STAFF REPORT

SUBJECT: Case #19-15 – 1080 Kings Hwy – McDonald's USA, LLC

Request to consider **Site Plan Review** for new construction of a 4600+/- SF fast-food restaurant and **Special Permit** for reduction of parking spaces, located at in the Planned Business and Industrial - A zoning districts.

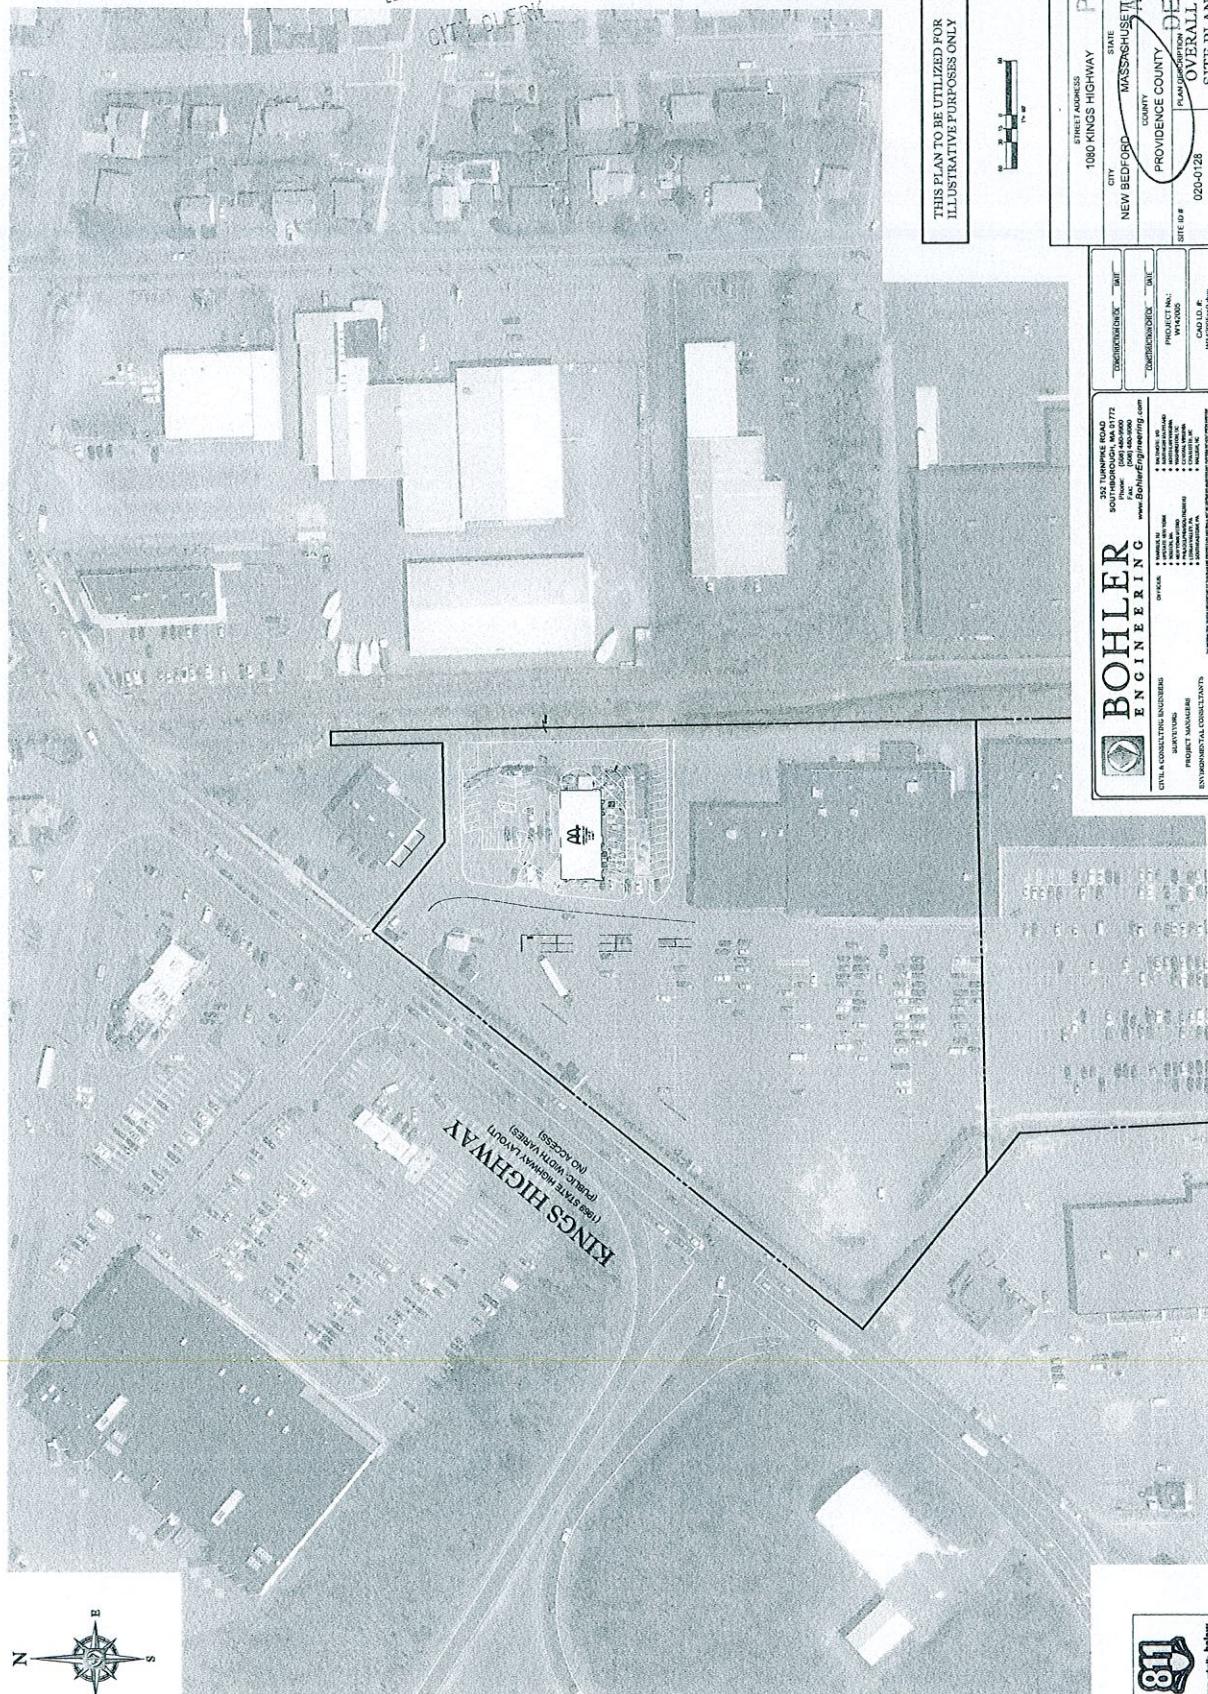
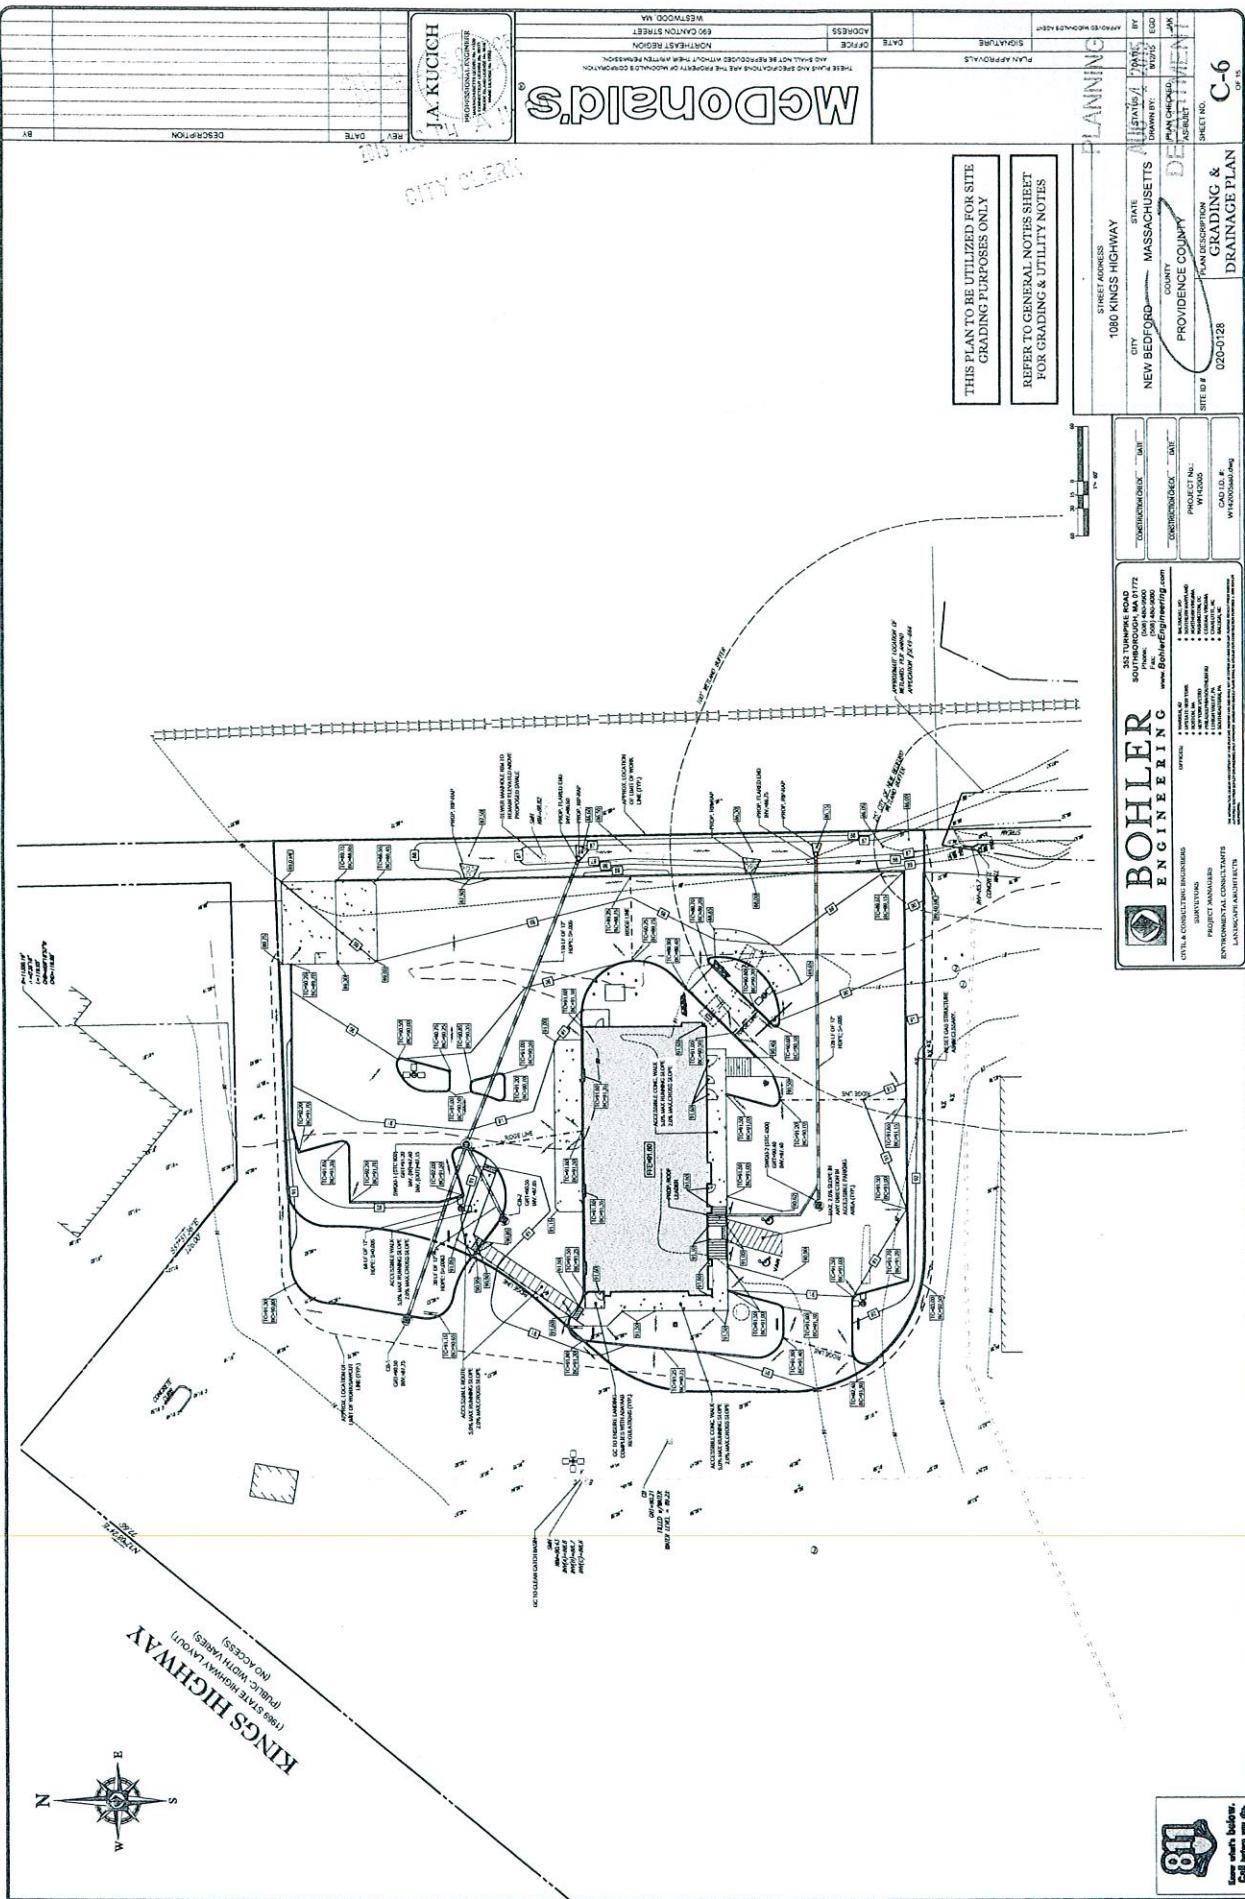
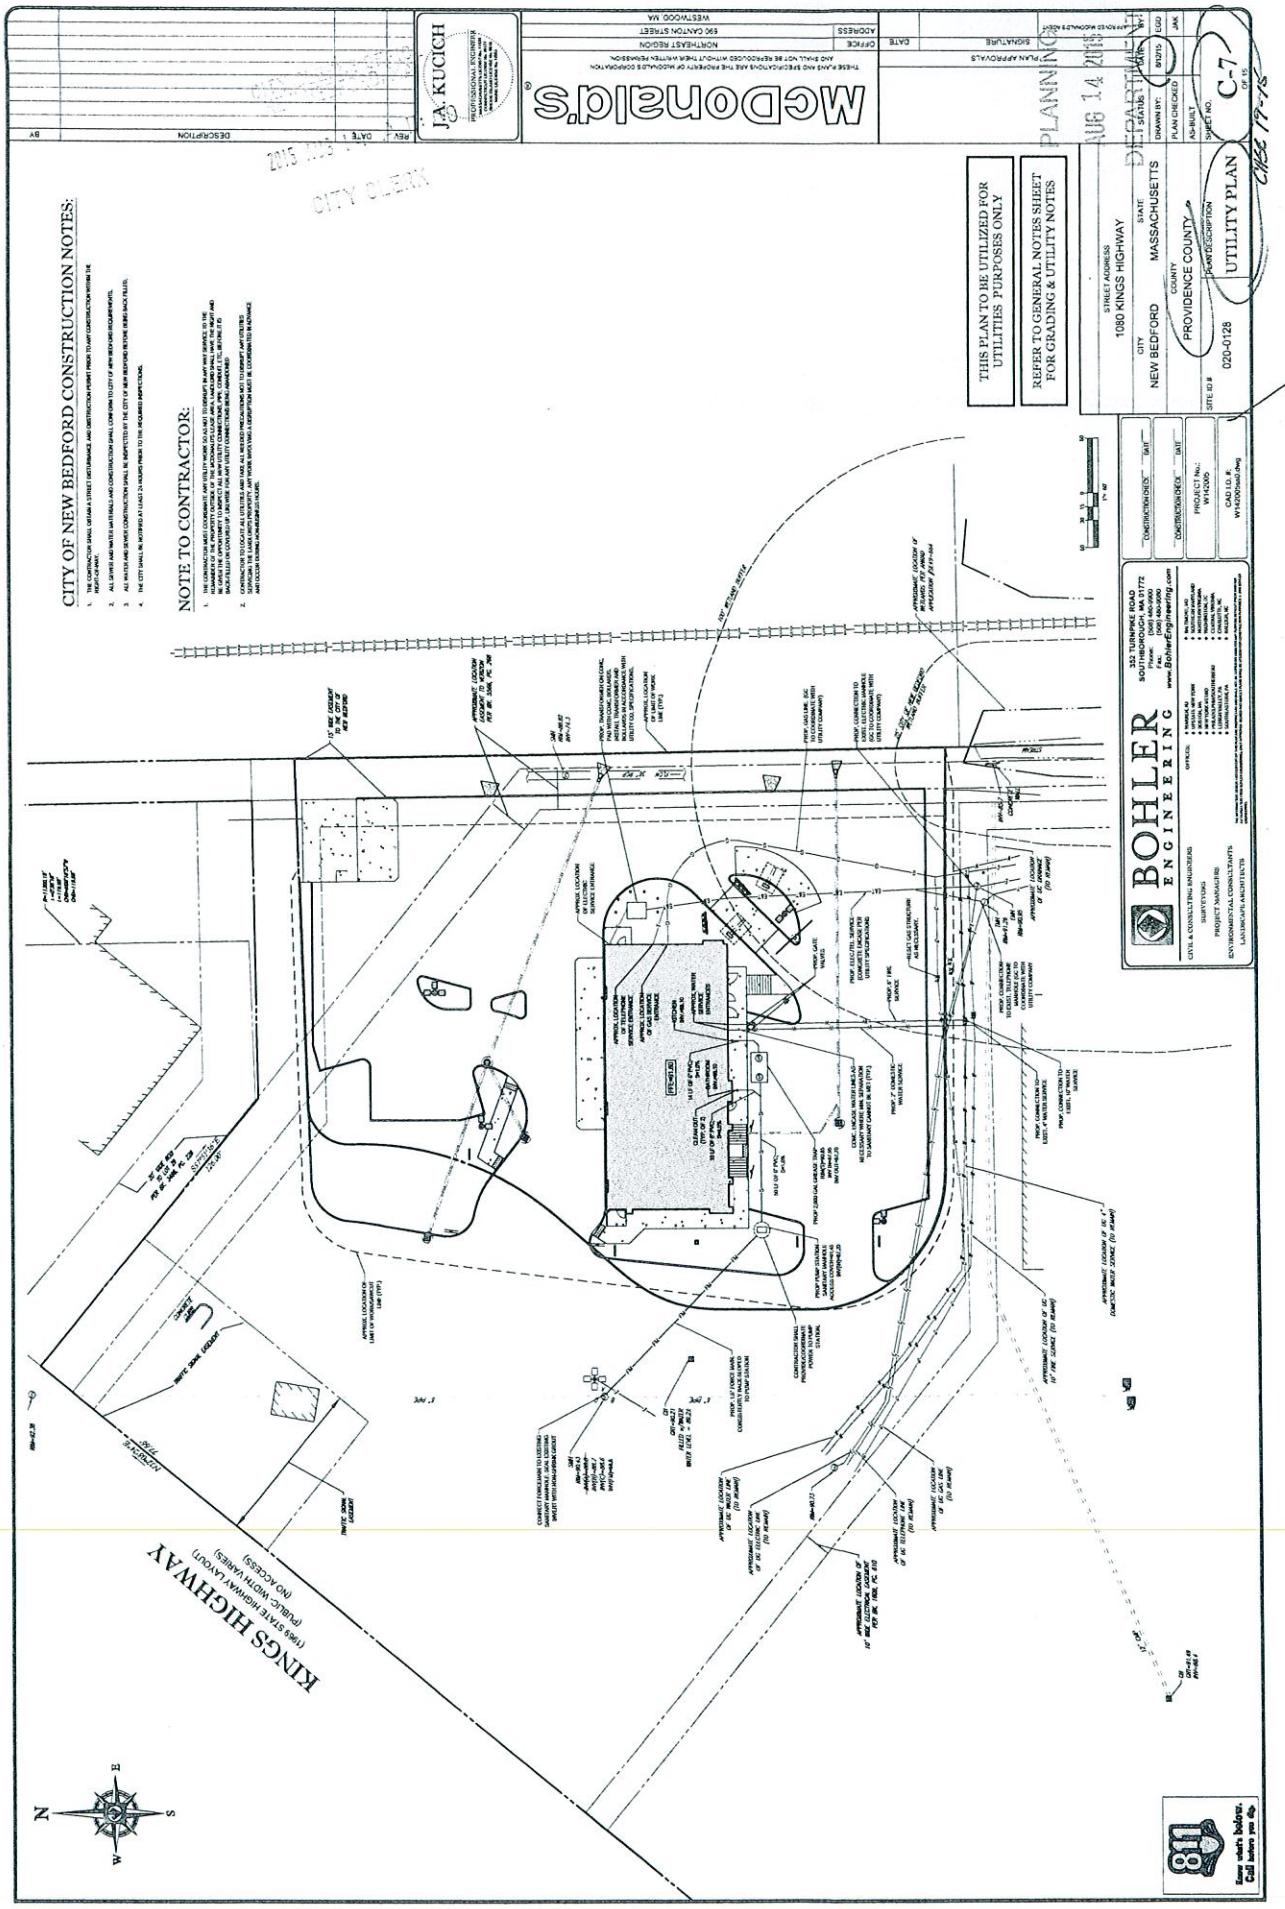
- Staff recommends the applicant provide a landscape plan noting the type and number of plantings that will enhance the site.
- Staff recommends stipulations and comments by Department of Public Infrastructure are included as conditions for plan approval.
- The Title Box reads, Providence County; plan revisions should read, Bristol County.
